Woolworths Regional Distribution Centre

11 Warren Road, Warnervale
NSW 2259

Access Review – DA 3 (Final)

24 March 2022

MAIN OFFICE AND AMENITIES FLOOR PLAN - LEVEL 2
SCALE: 1 : 100

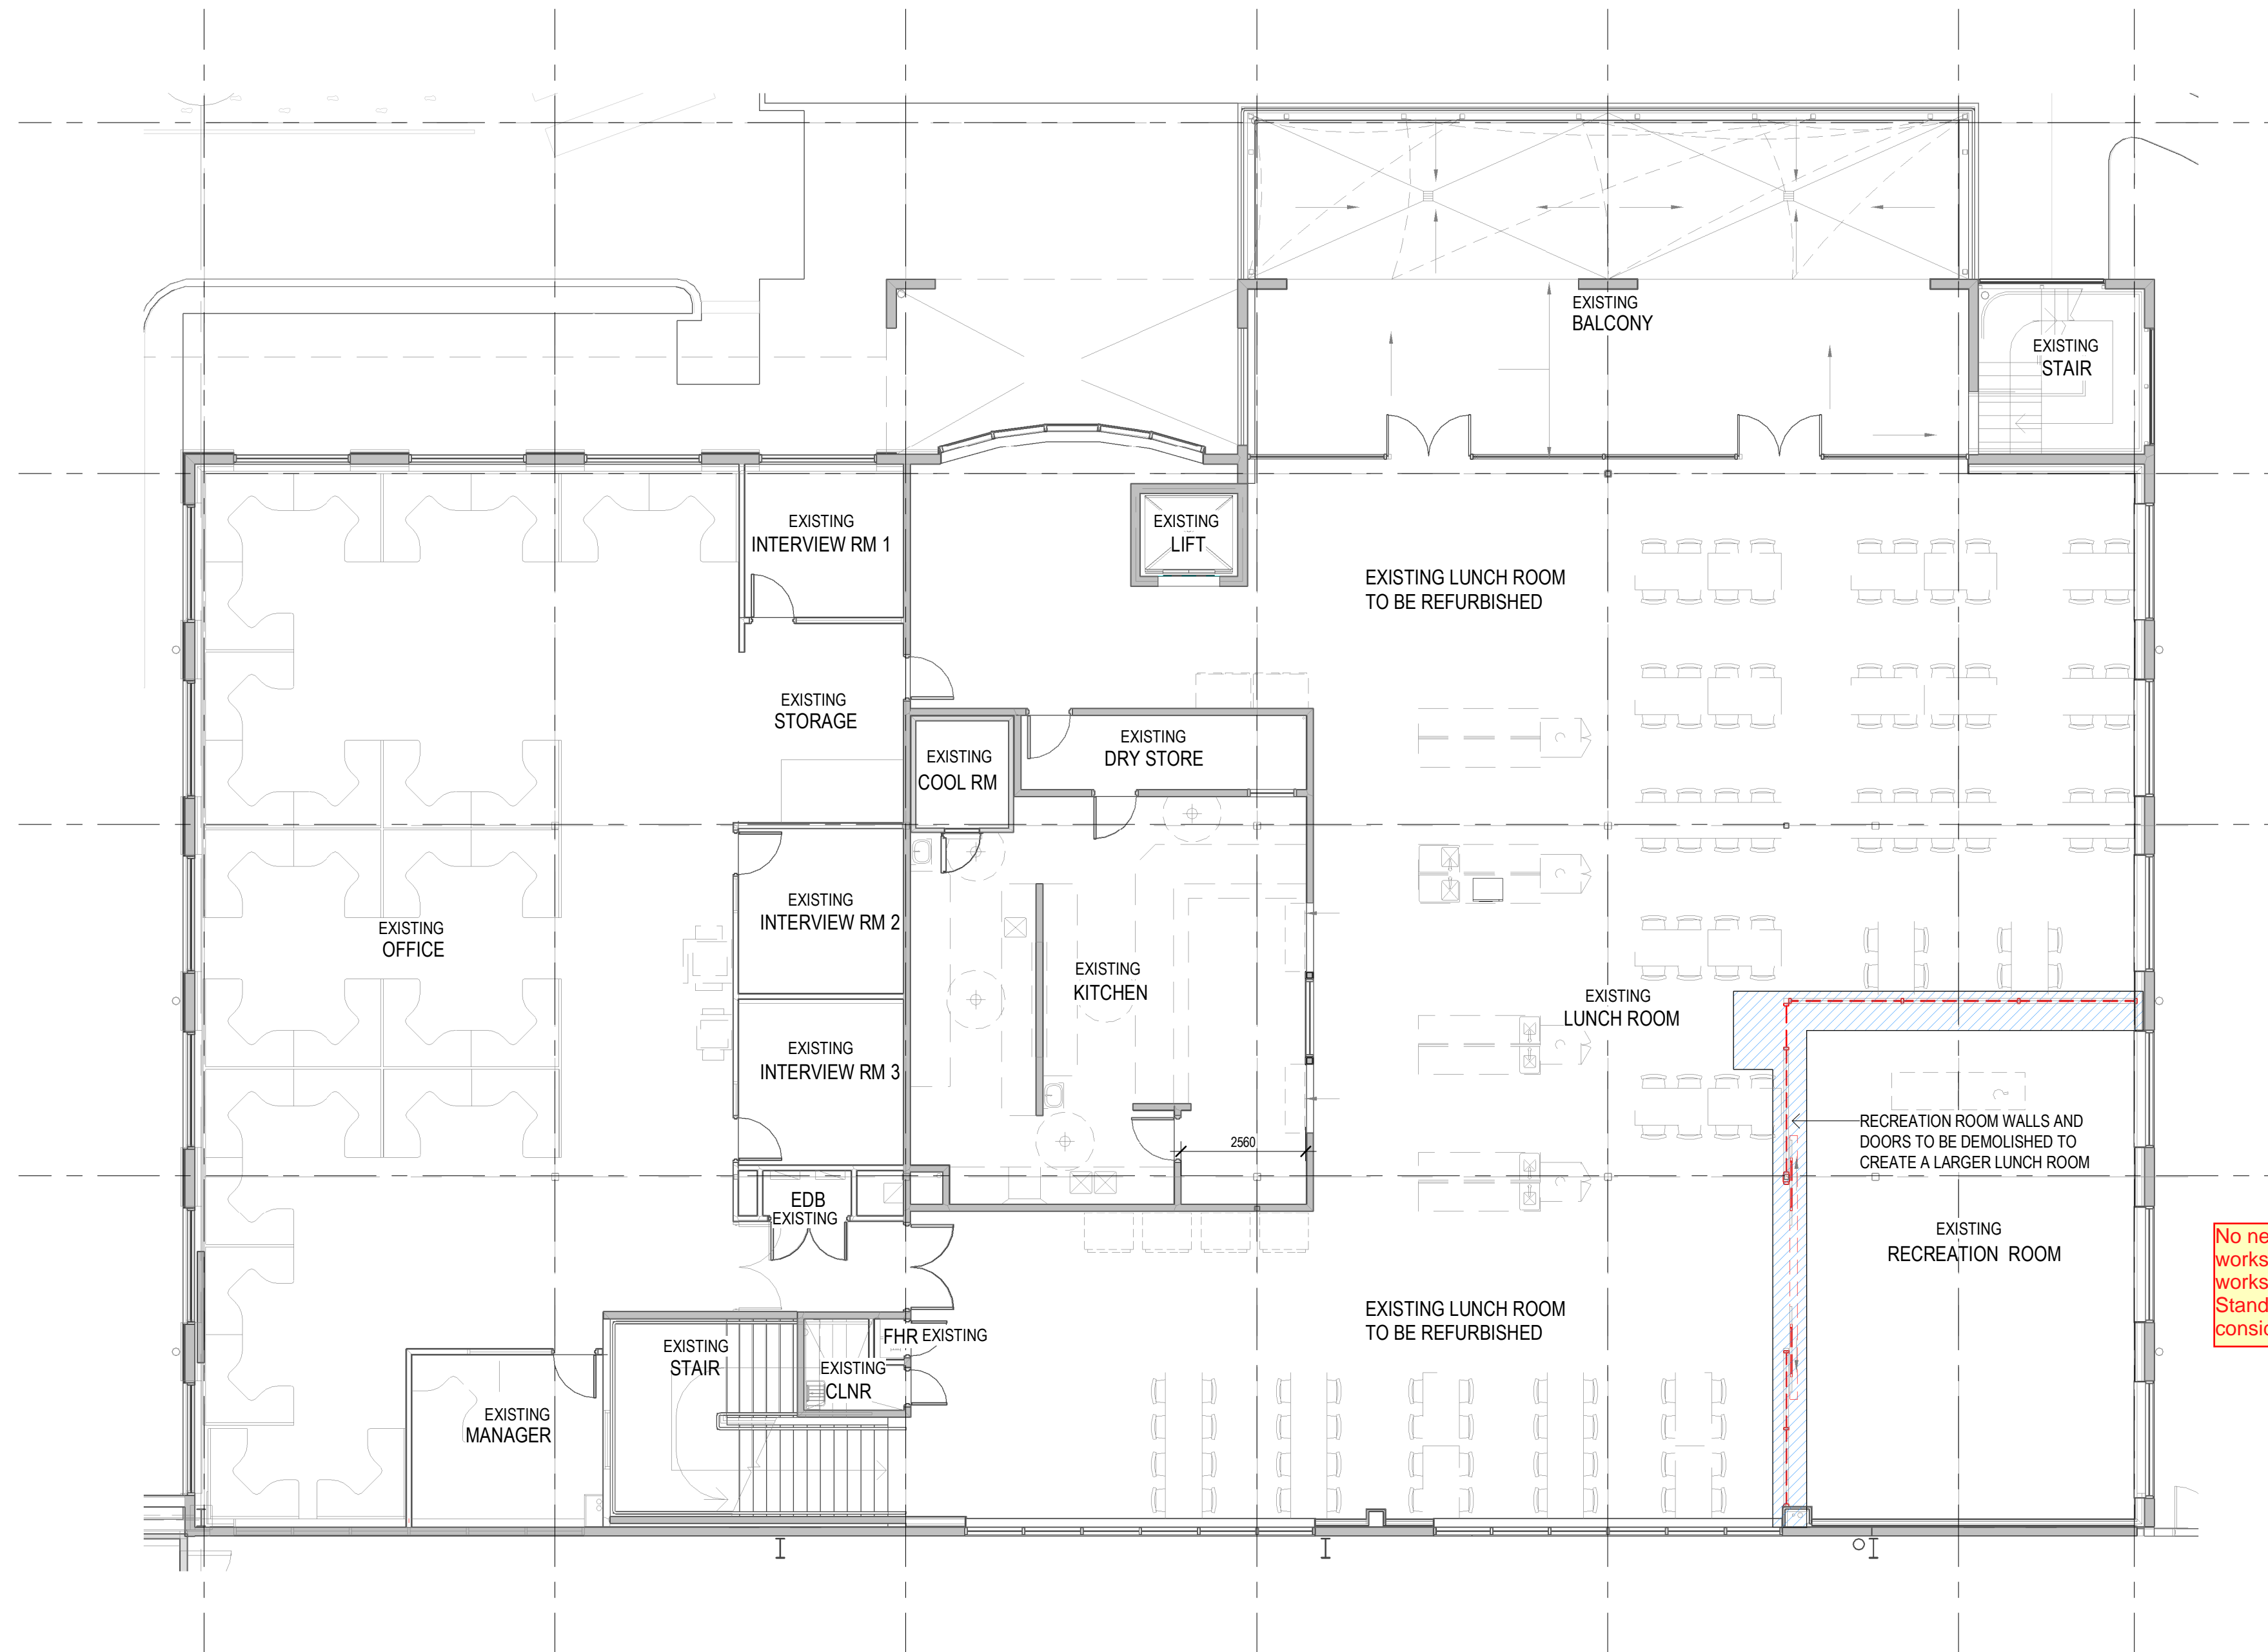
No new walls or new construction works proposed, hence no new works under the Premises Standards affected part to be considered.

TC OFFICE AND AMENITIES PLAN
SCALE: 1 : 50

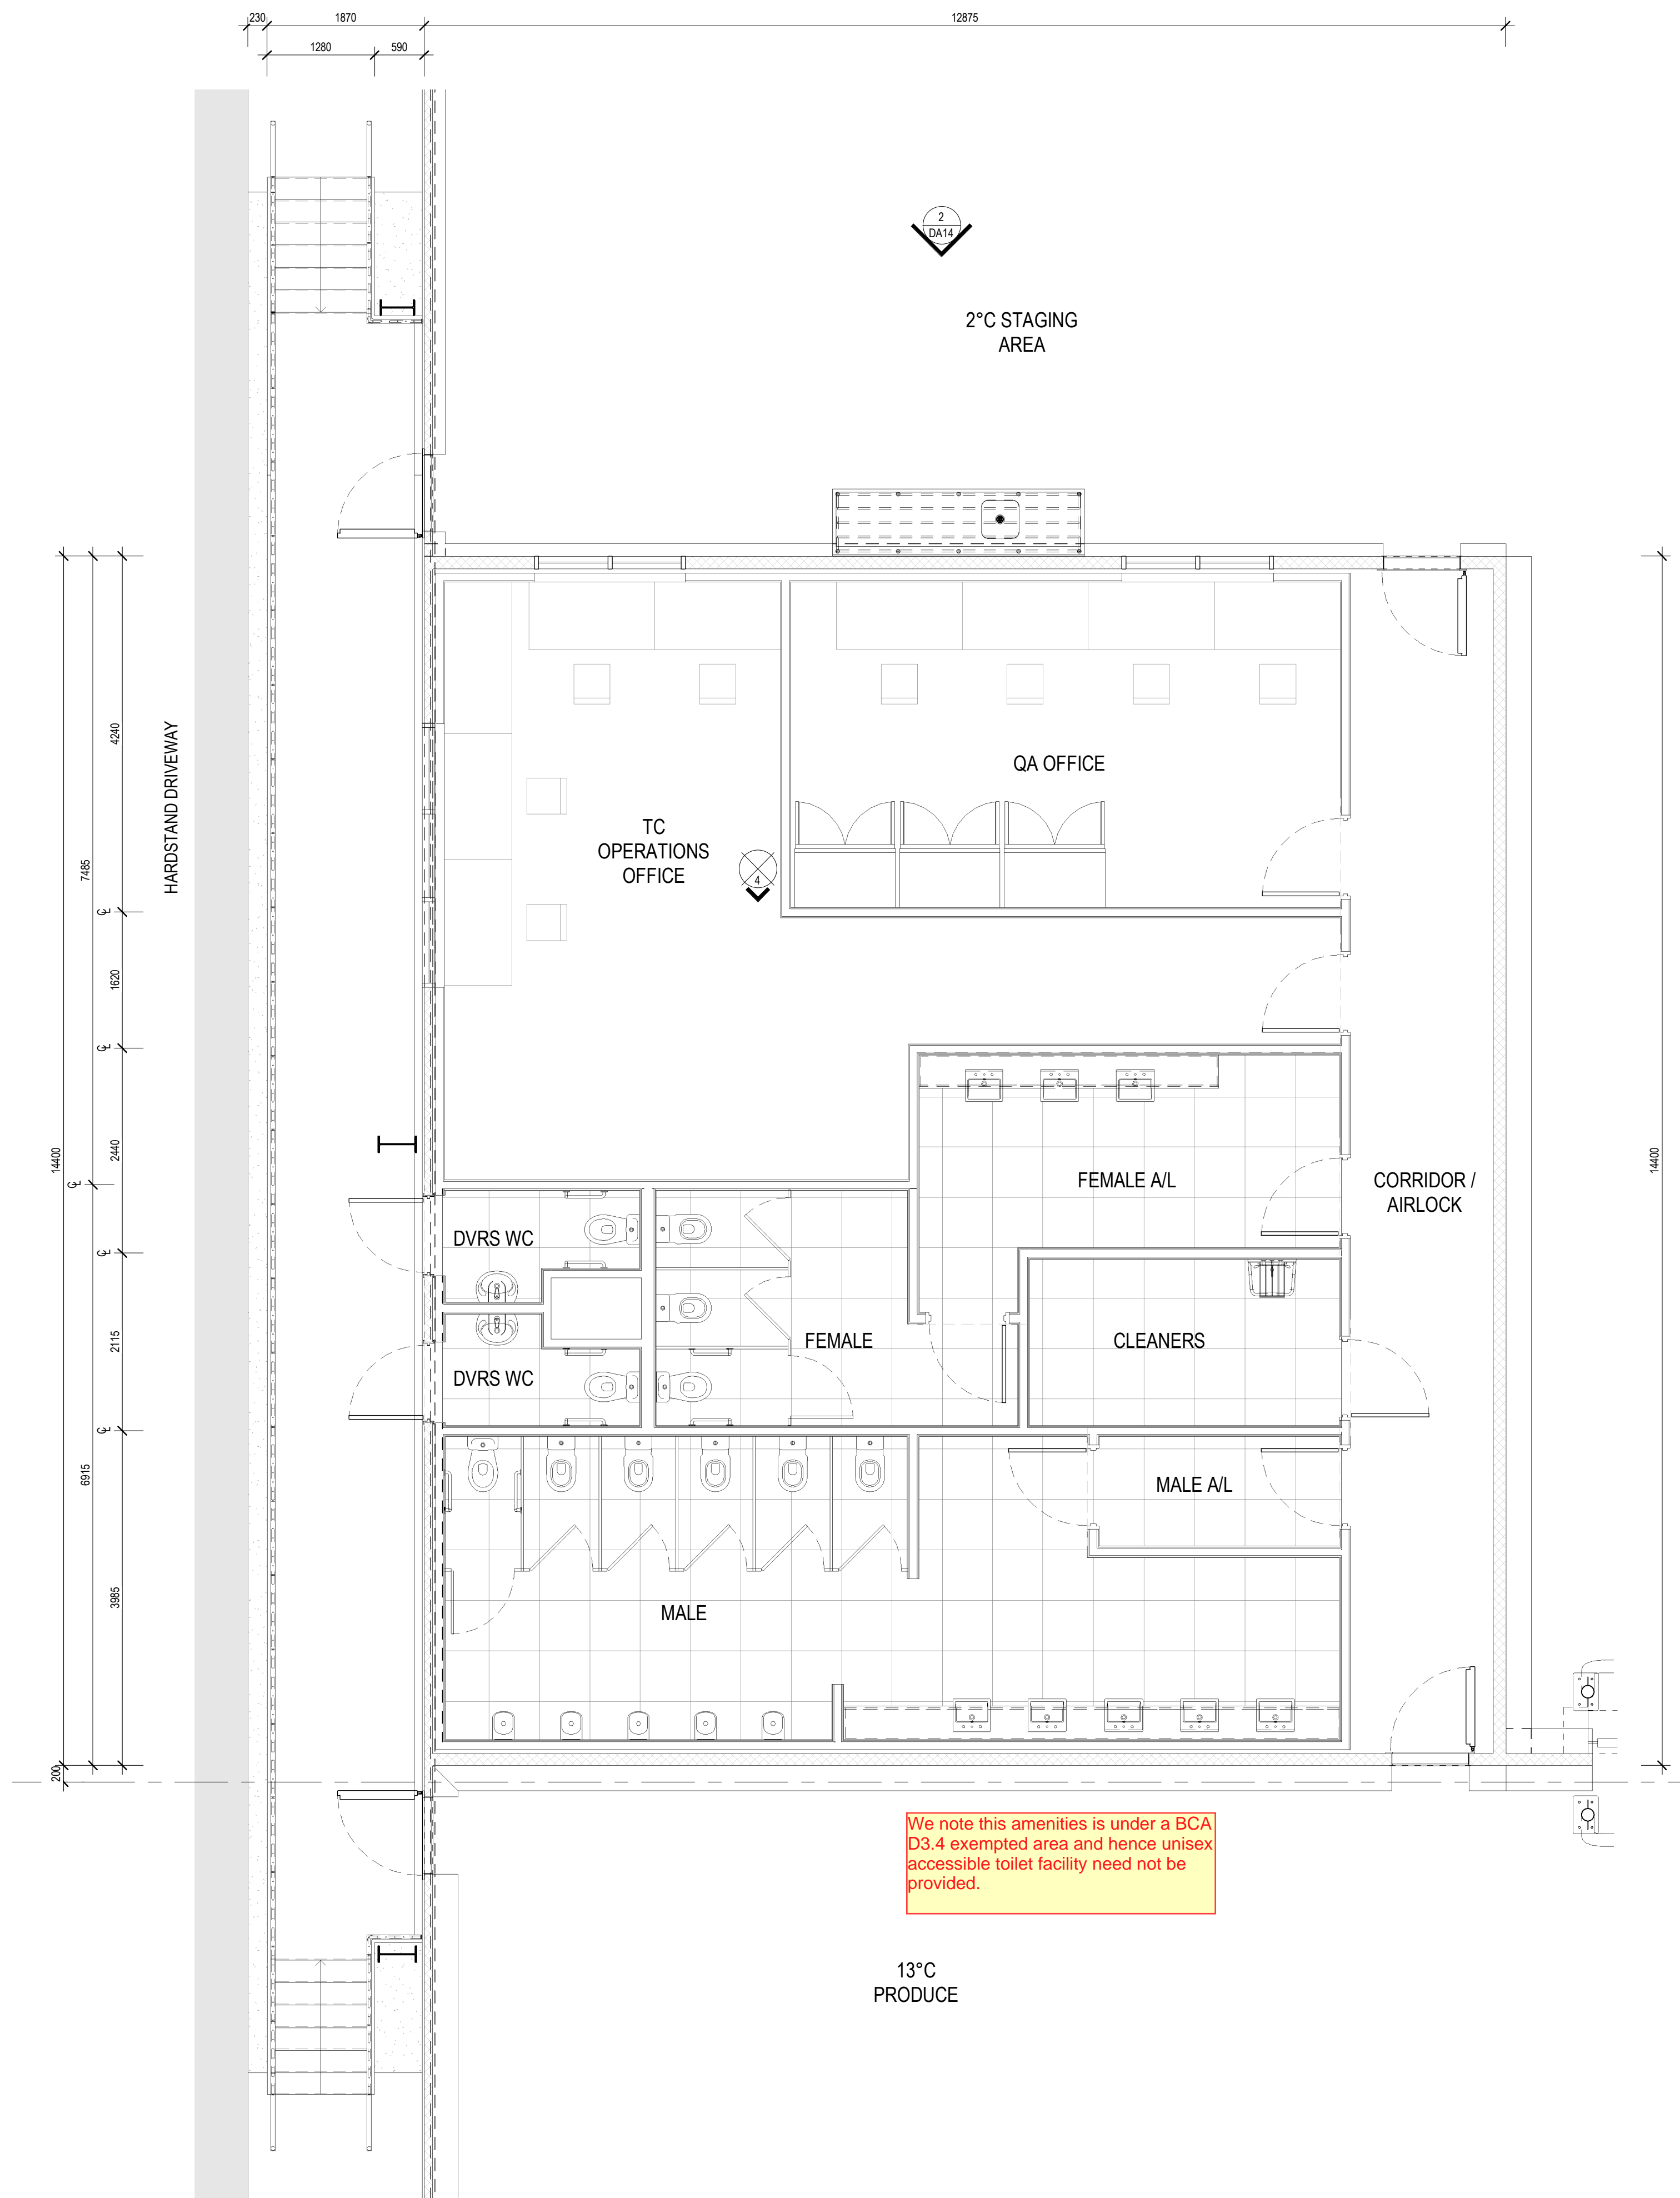
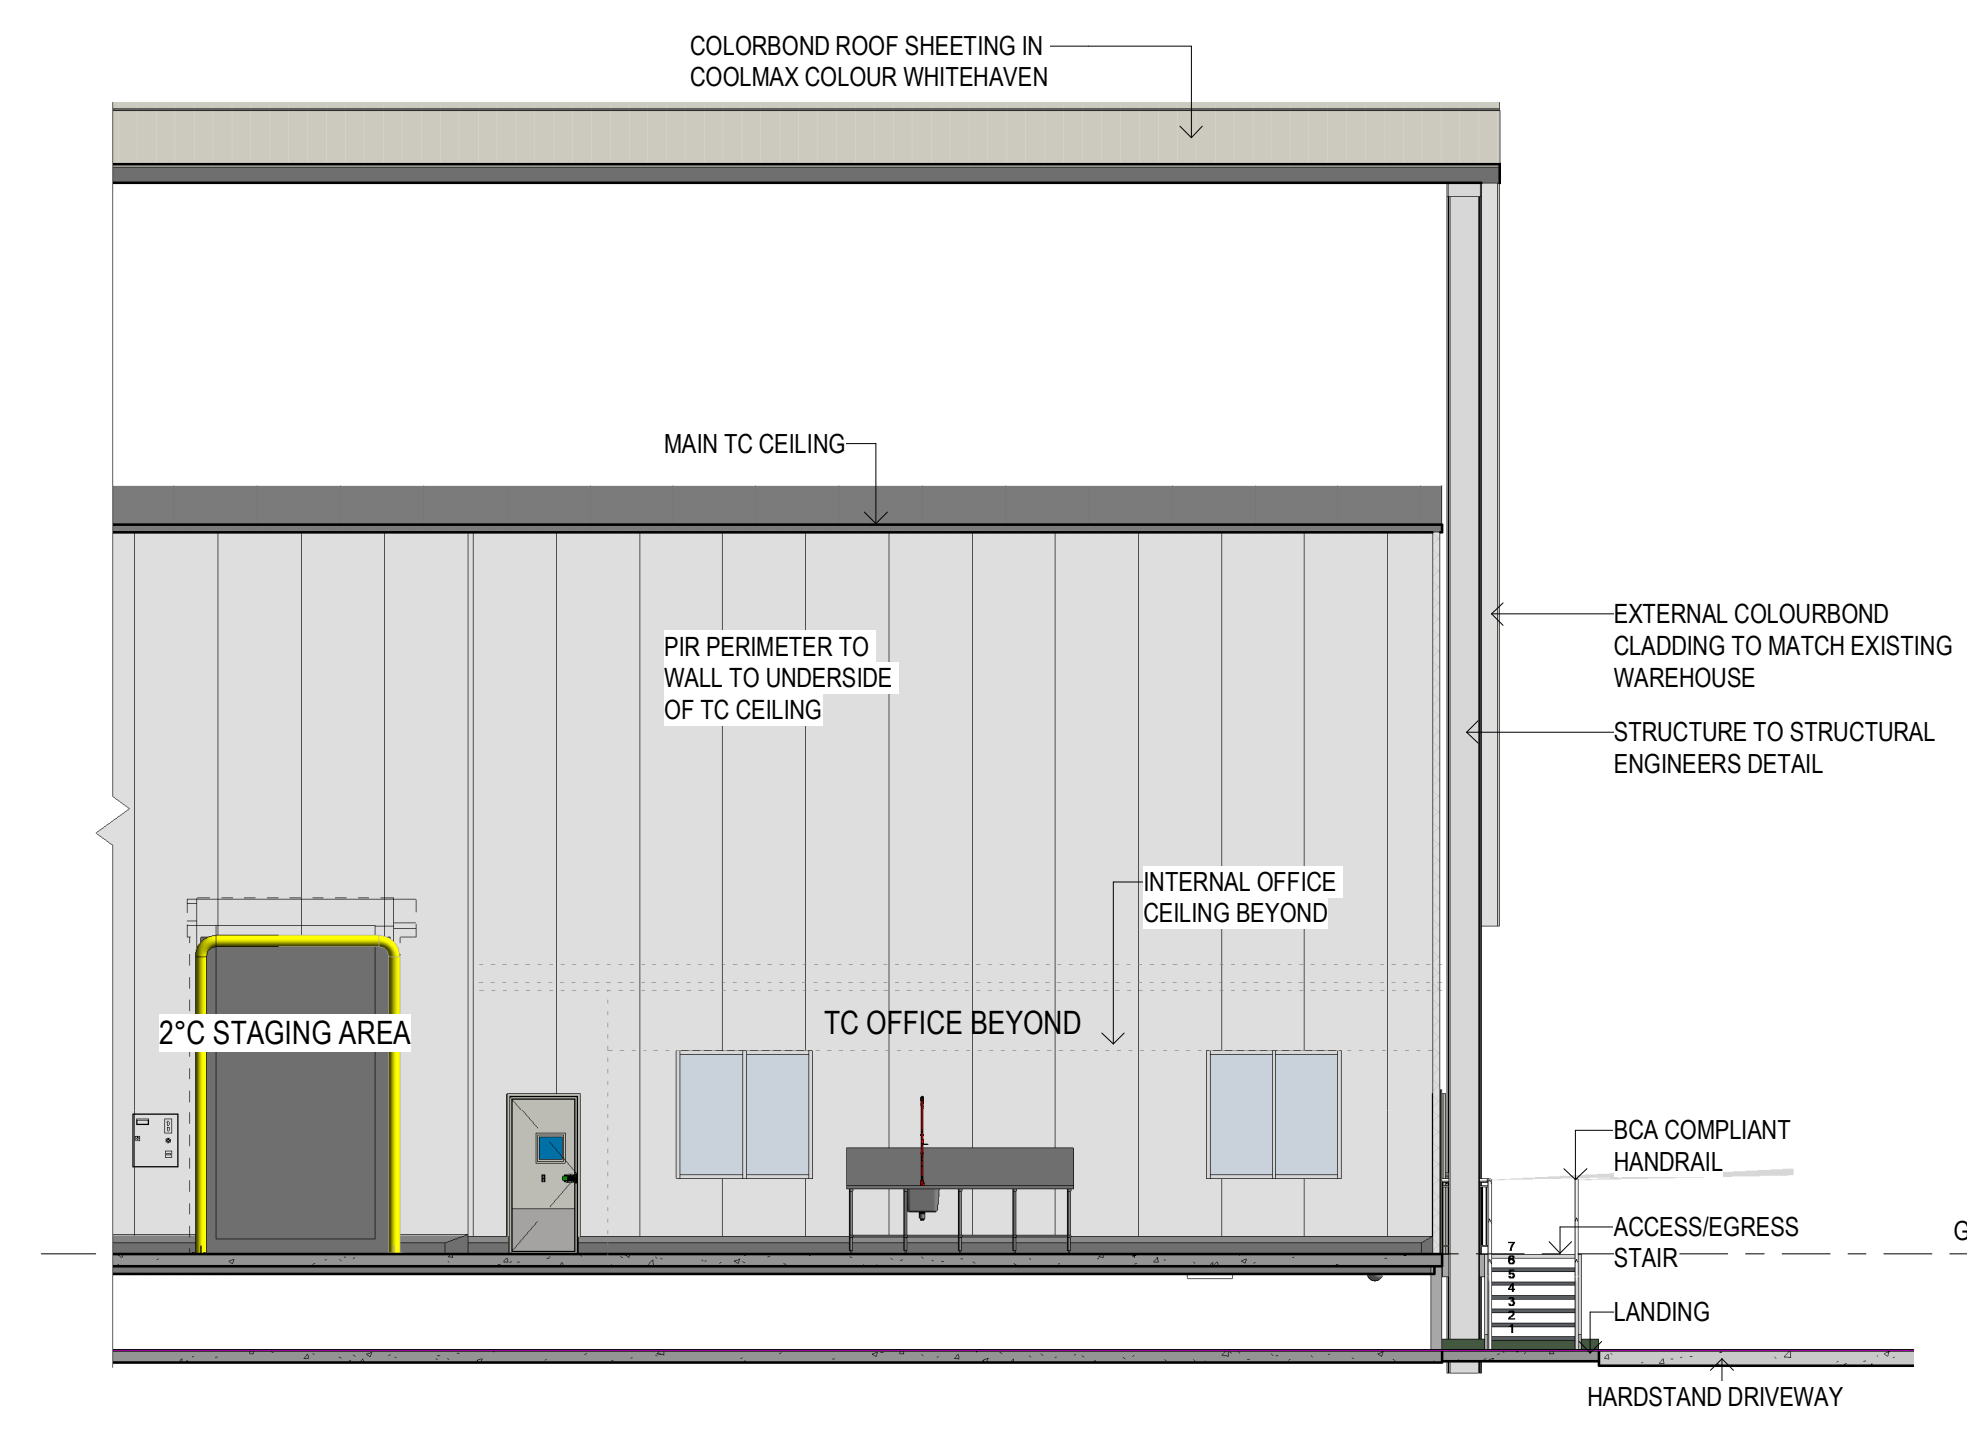
We note this amenities is under a BCA D3.4 exempted area and hence unisex accessible toilet facility need not be provided.
